Required Dealer Action

Figure 2. 31400109A

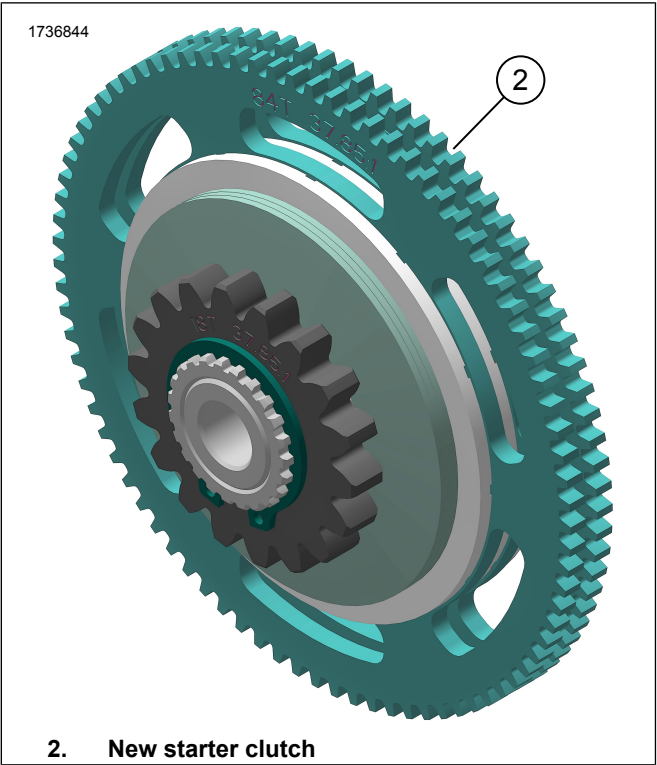
When diagnosing a starter whine condition (see Supplemental Procedure Video), replace the starter clutch gear with (Part No. 31400109A). The updated starter clutch gear was put into production on January 13, 2022. Replacing the starter clutch gear will cure the starter whine condition only. The starter clutch gear should not be replaced to attempt a repair for any other starting concerns.

Remove starter clutch gear inventory of (Part No. 31400109) from dealer stock. File a DFS claim to remove from dealer inventory.
